Hurricane Planning Commission Meeting Agenda

January 12, 2023
5:00 PM

Agenda Date:	01/12/2023
Application Number:	2022-PP-24
Type of Application:	Preliminary Plat Application
Action Type:	Administrative
Applicant:	Western Mortgage and Realty Co
Agent:	Brent Moser
Request:	Approval of a Preliminary Plat
Location:	South of Sand Hollow Road and West of 3700 W
Zoning:	Recreation Resort
General Plan Map:	Planned Community

PRELIMINARY PLAT FOR:
GATEWAY AT SAND HOLLOW RESORT
LOCATED IN SECTION 1, T42S, R14W, S.L.B.#M.
HURRICANE CITY, WASHINGTON COUNTY, UTAH

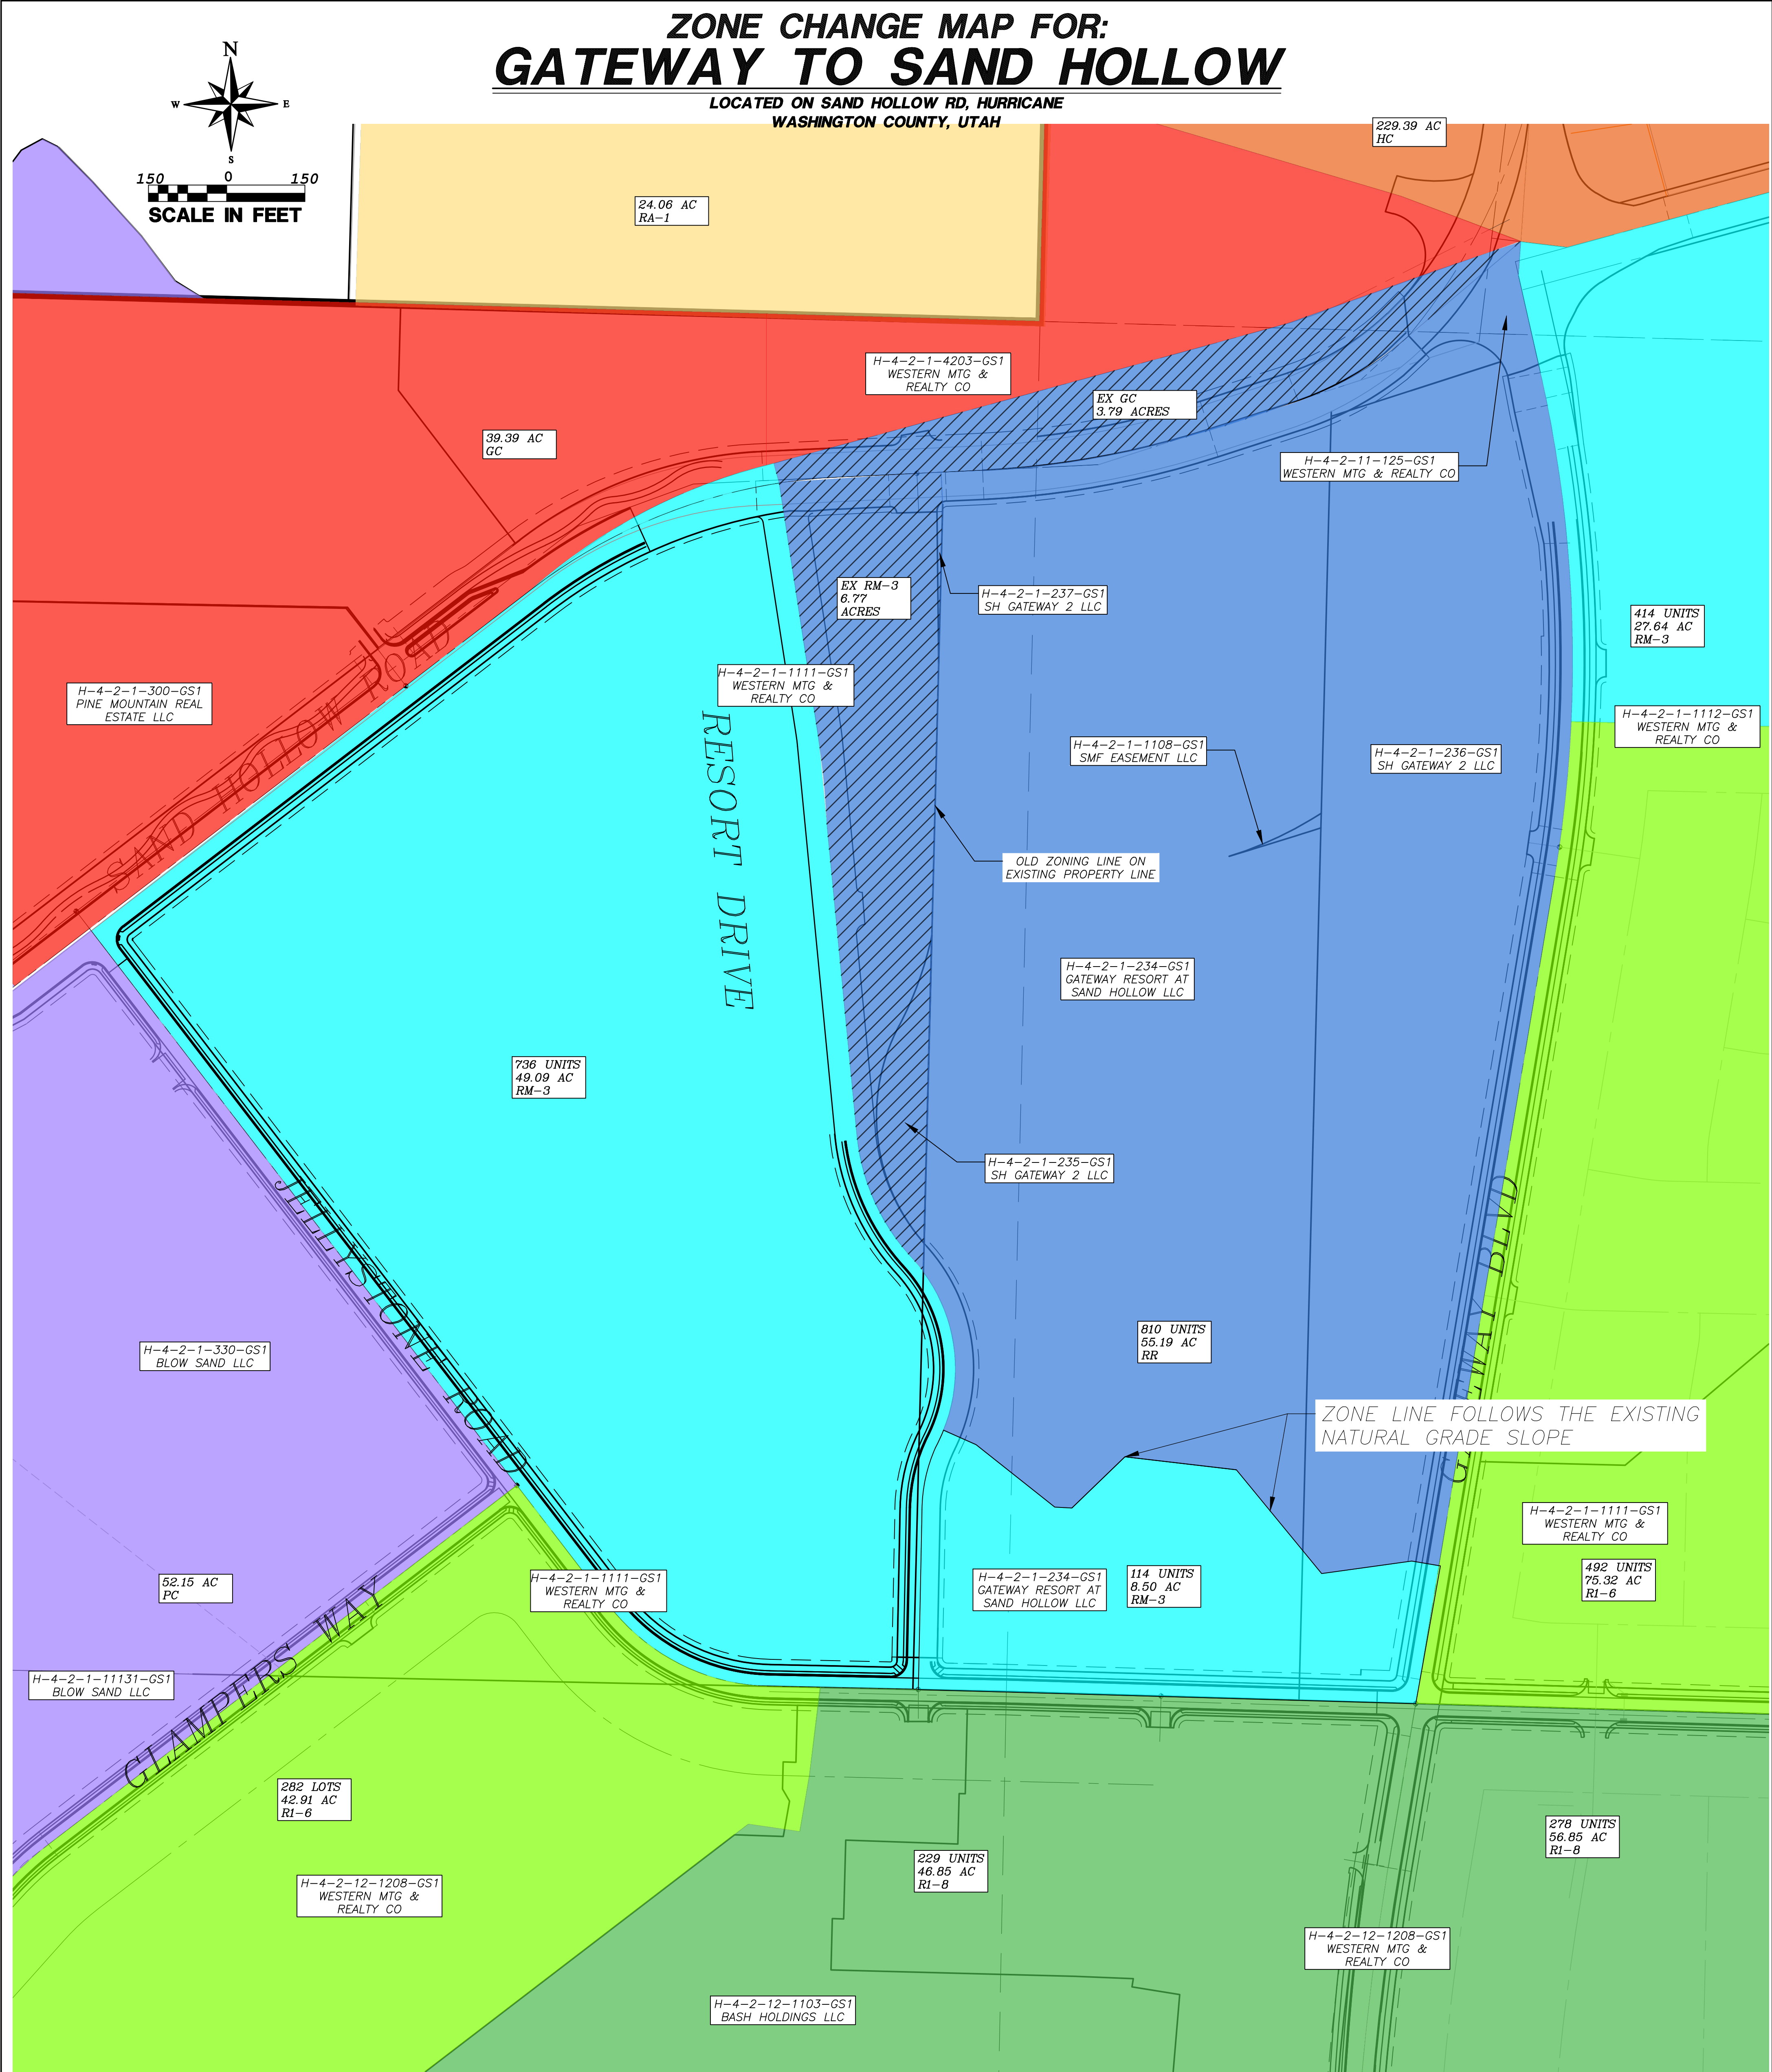
- The approved zone change exhibit shows 810 resort units and 114 RM-3 units and the proposed preliminary plat shows 882 resort units and 117 RM-3 units. The application will need to resolve the density at issue prior to approval.

- Staff note 2 (parking) has not been addressed. As laid out below, staff does not believe their plan to meet their trailer parking requirement on a site near Sand Hollow Lake will be able to meet City Code
- They have added a note regarding the amenity requirements in Chapter 26 of the Hurricane City Code. They say they are providing 4,000 sq ft of clubhouse space, however as laid out below 5,500 sq ft are required.
- Will serve letters have not been received
- Site data table on page 2 directly contradicts information on page 1
 - Land Use Summary Table on Page 1 has several errors and inconsistencies
- Other comments within this report are still applicable except those regarding zoning which was resolved with the zone change.

should use a standard engineer scale for more detailed sheets 1"=60' is the largest standard scale. Legal description is incorrect. Block lengths exceed 800' additional public ROW are needed to reduce block size, provide additional fire access, and provide locations for water looping. Some buildings in phase 13 will be hard to access because of grades. Proposed cross-sections do not match standard cross-sections and it is not clear which roads these are for. It appears greater consideration for existing grades should be given: several roads will be over 10% grade, Phase 31 building will require over 30' of fill in order to work.

- a. The approved zone change map for this area shows 59 acres of Recreation Resort which would be 885 units. Part of the property being depicted on this site plan stretches into the RM-3 zone to the west.

- a. The site plan indicates that parking spaces 3091 are required and 3091 spaces are provided in a mix of outdoor parking and indoor garage parking.

- b. RV/trailer spaces are also required at a rate of one space per five units. 189 trailer parking stalls are required. The applicant has told staff that they intend to provide these parking spaces in an area offsite closer to Sand Hollow Reservoir. The Planning Commission does have authority under HCC 10-34 to approve off-site parking or modified parking requirements. Without a specific plan of where the parking will be located, how many spaces are provided, and how people will get from the offsite location to the site, staff does not recommend the approval of the parking plan as presented.

Recommendation: Staff recommends the Planning Commission review this application based on standards with Hurricane City Code. Due to the issues of zoning (currently under consolidation), parking, lacking will-serve letters, redesign of Sand Hollow Road, and amenities; staff recommends denial or tabling of this preliminary plat until all the issues raised can be adequately addressed.

SHEET NO.
C1

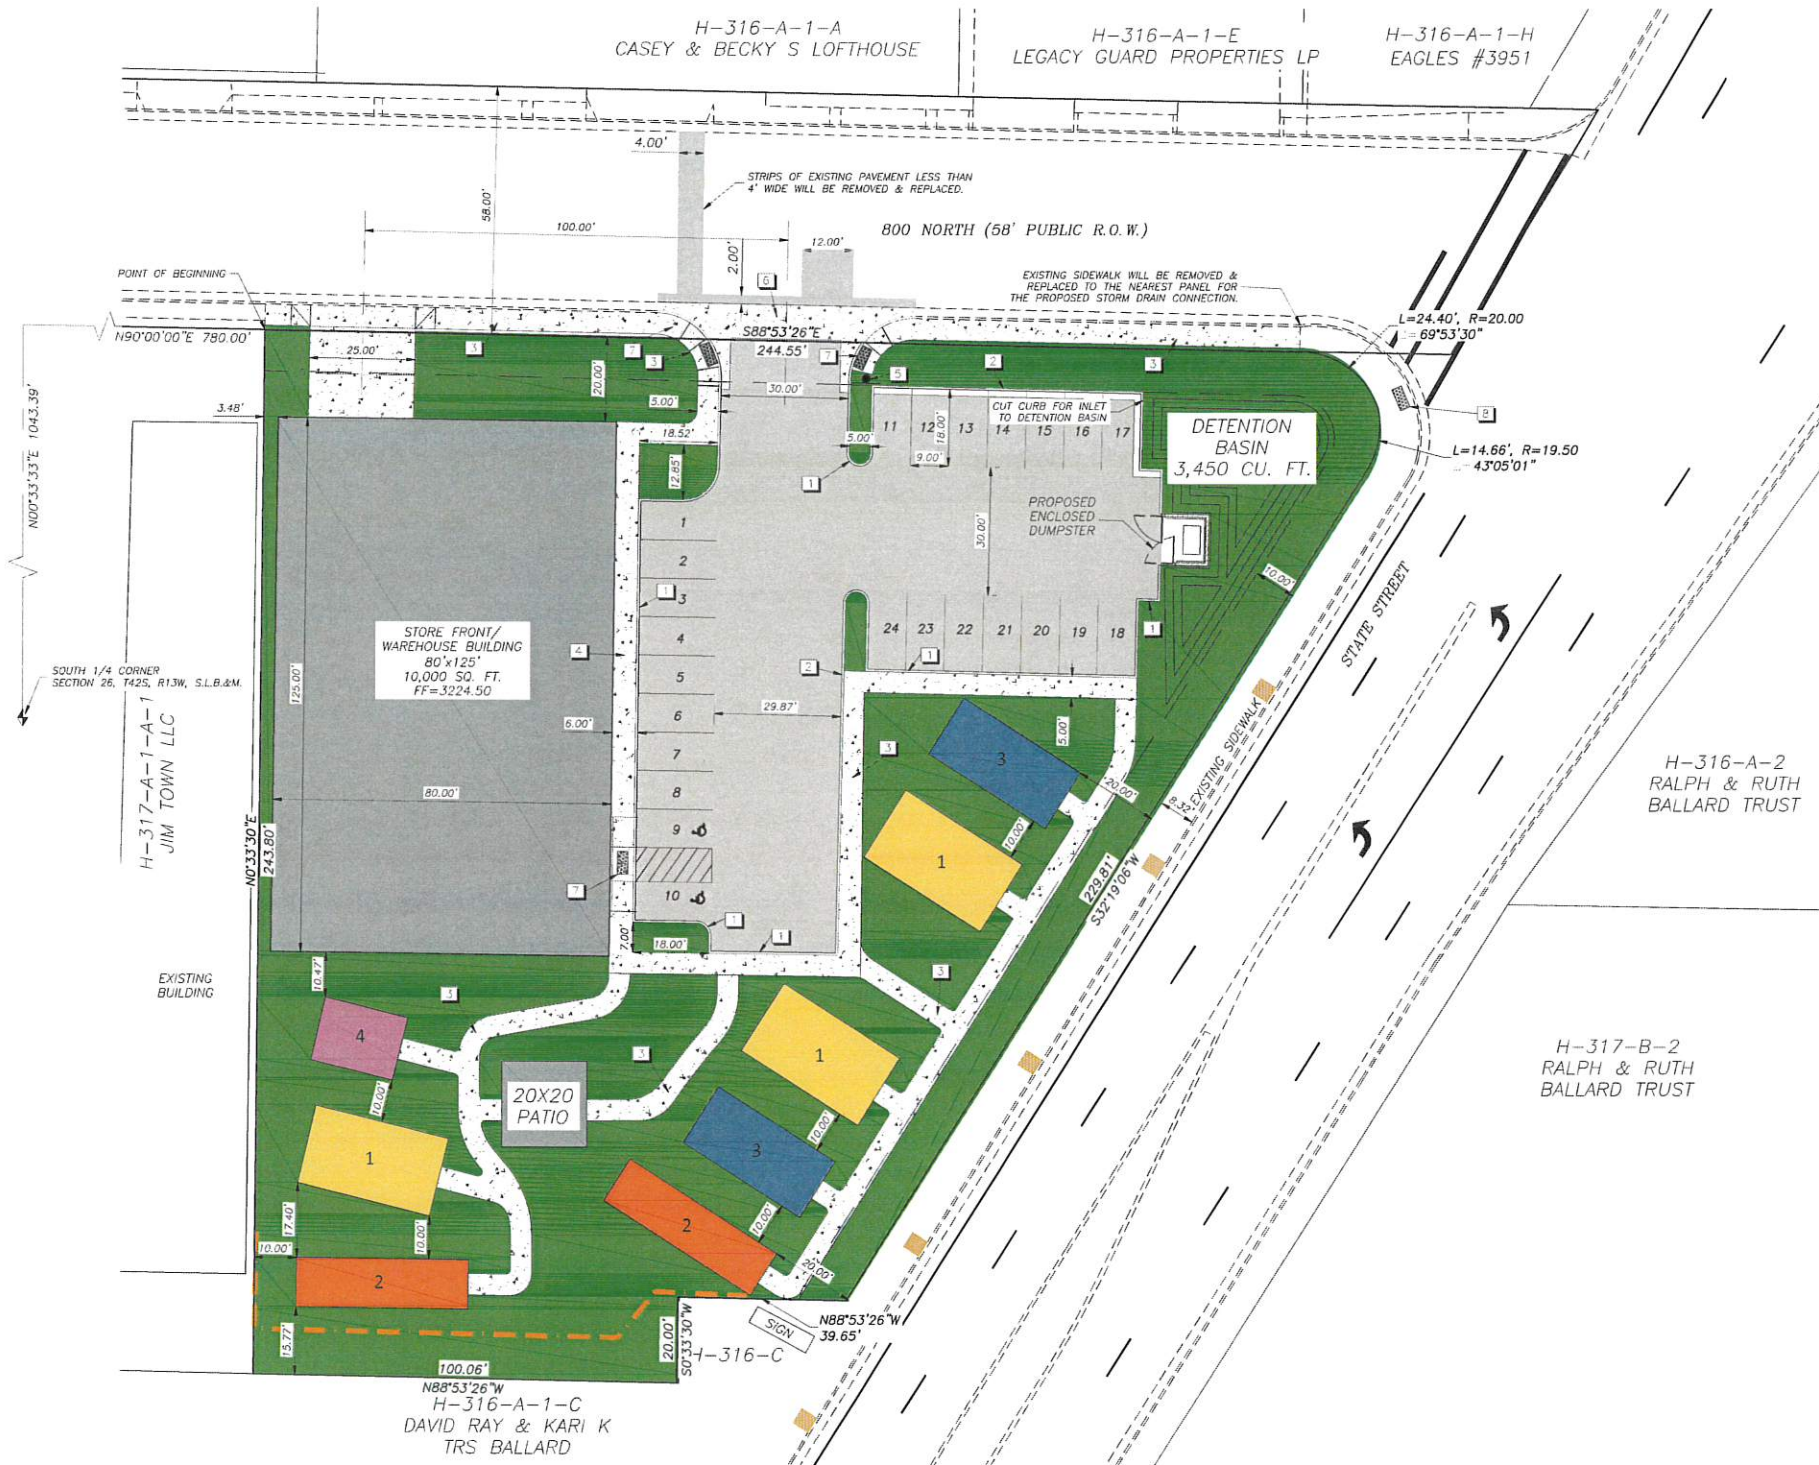
3. The site plan currently states that 19 parking spaces are required, but they show 24. Staff's main concern is that it appears that the parking requirements are only shown as if the whole building is a warehouse, which is not the case. The site mixes retail/office, warehousing, and short-term rental stays. Each use needs to be considered for the parking requirements.

Recommendation: Staff recommends the Planning Commission review this application based on standards with Hurricane City Code. Staff would recommend continuing this item unless the applicant can address the parking issues, landscape, building facade material, and onsite management for motel use.

LANDSCAPE PLAN FOR:
BRYSON YOUNG CONST

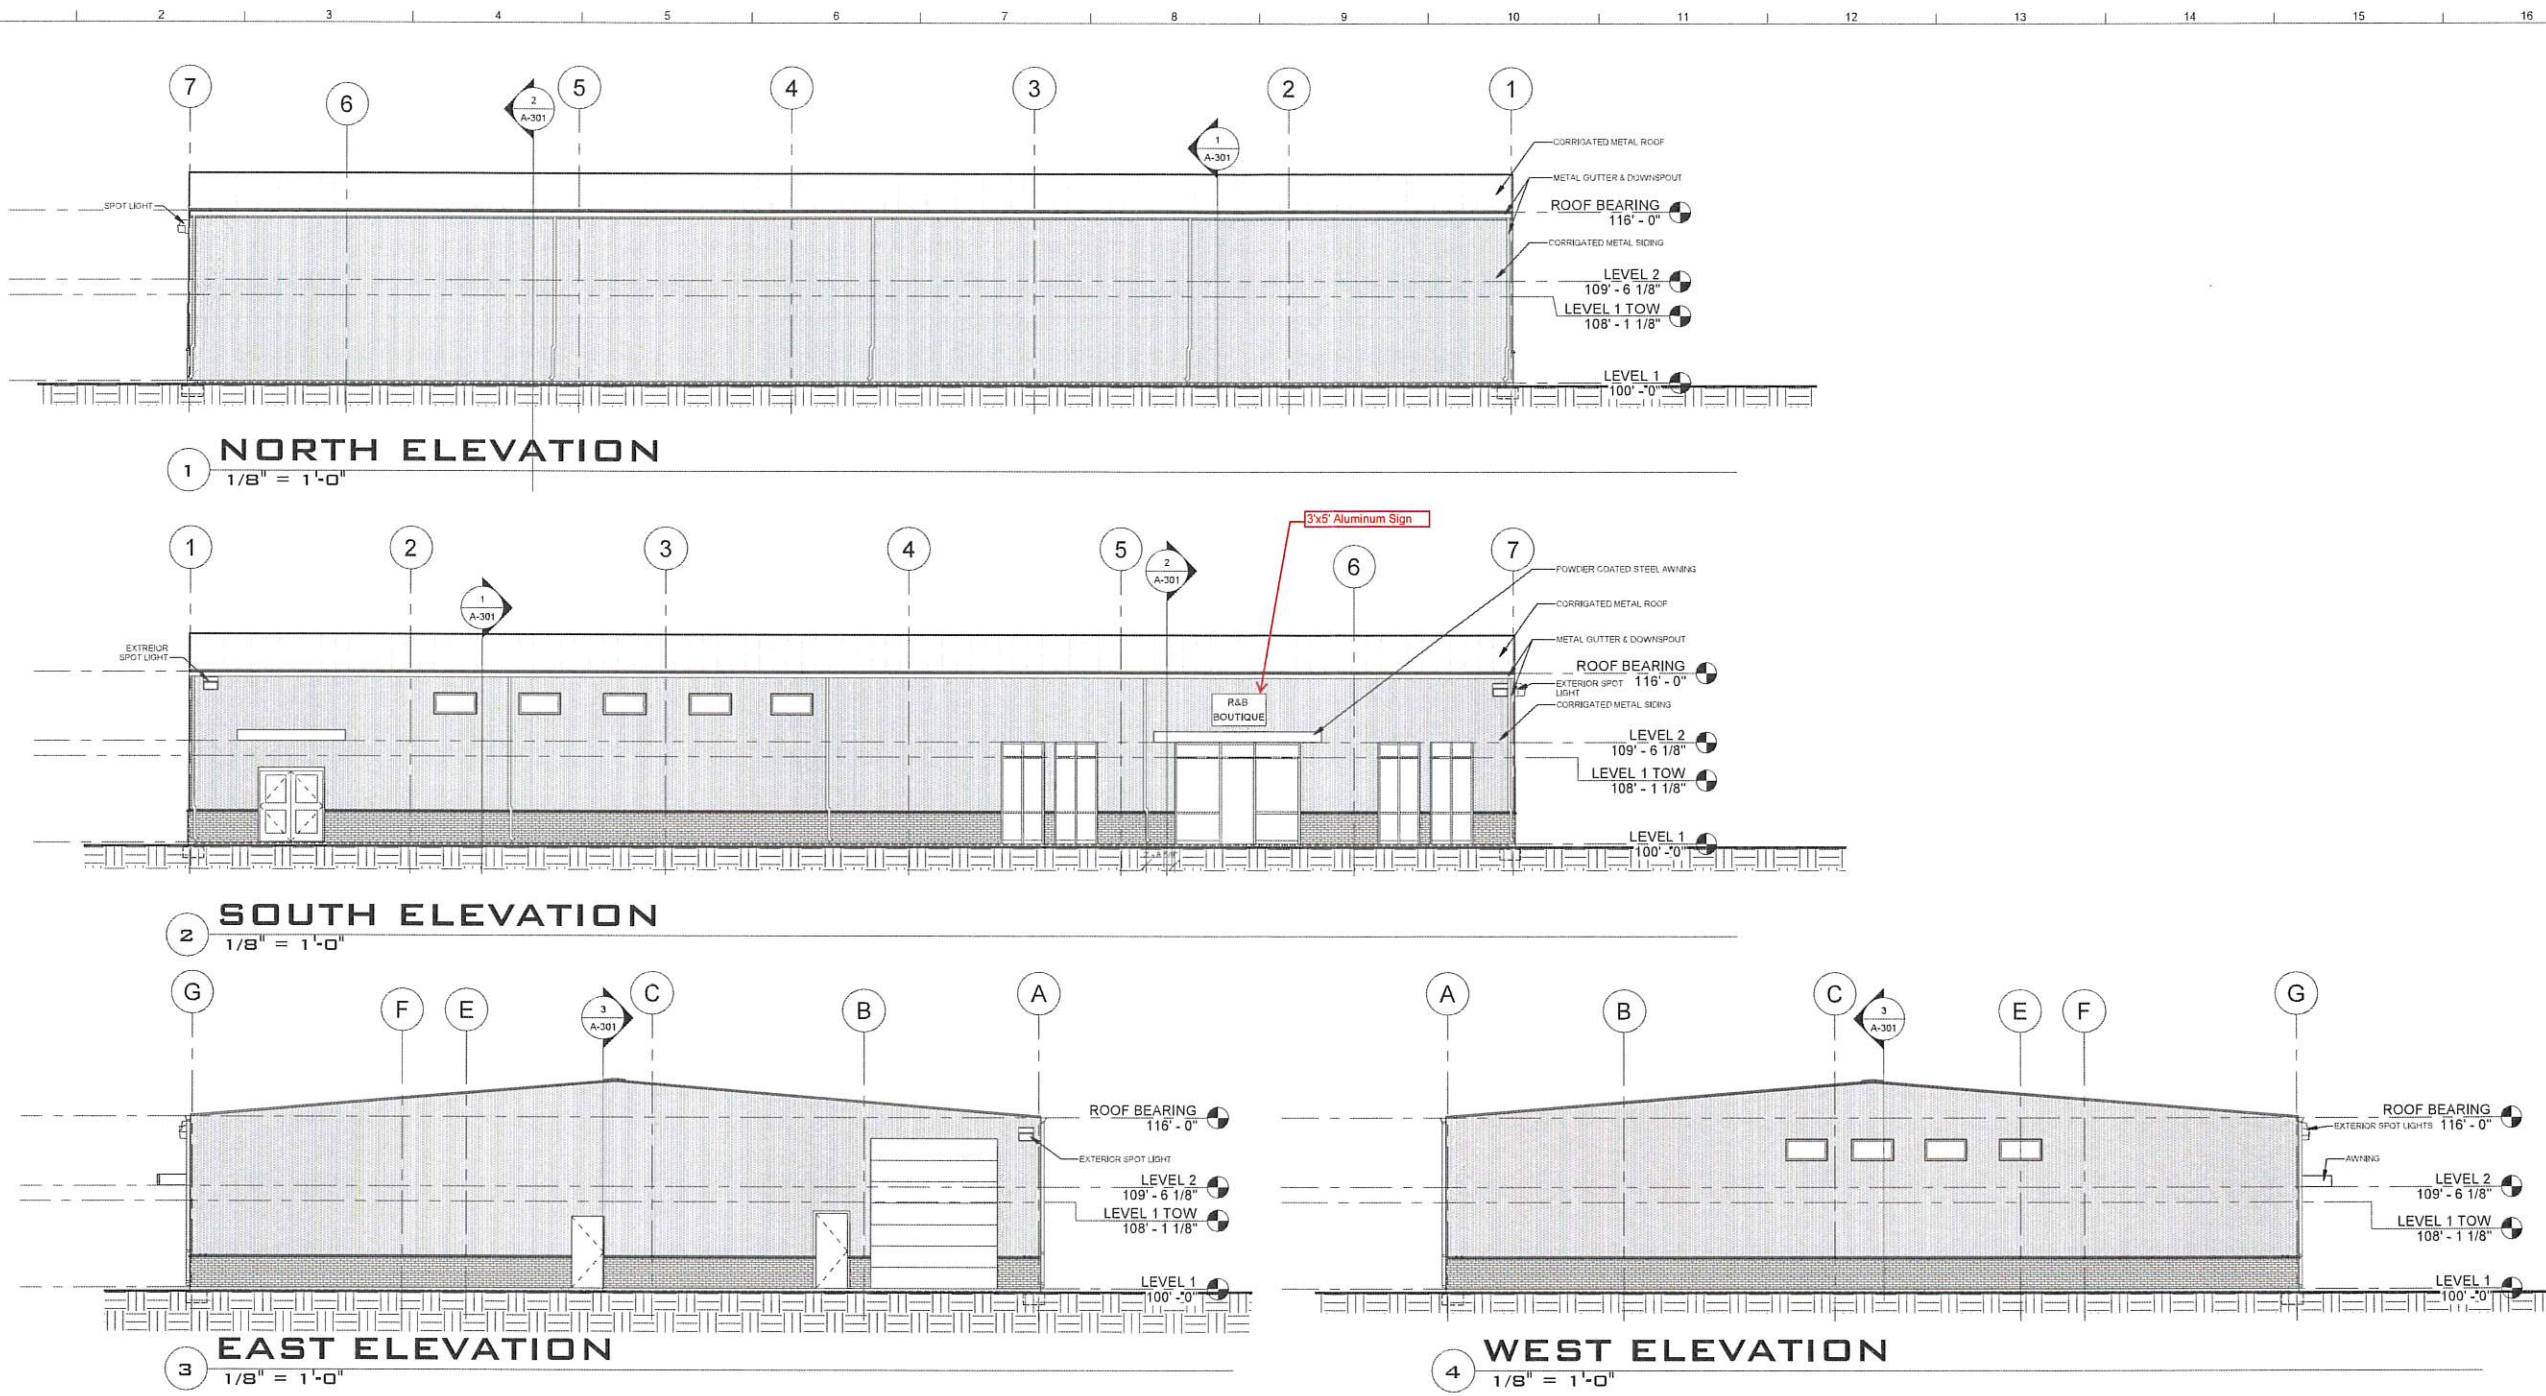
- 4. A full landscape plan has been provided. Staff is concerned about the number of trees being proposed.
 - a. For the 10' landscape buffer, the City requires one tree and three shrubs every 35' of frontage. For the 540' of frontage, the number of trees that would be required is a total of 15 trees and 46 shrubs. The plan only shows 11 trees and 51 shrubs for the site.

- b. The City also requires 1 tree and two shrubs for every 10 parking spaces, which is not shown.
- 5. The applicant has provided building rendering for the retail and warehouse buildings and for the smaller units. The warehouse/retail building does not indicate what the facade will be. If the applicant is planning to be a metal building, that will require a conditional use permit. The applicant needs to indicate what the facade will be.
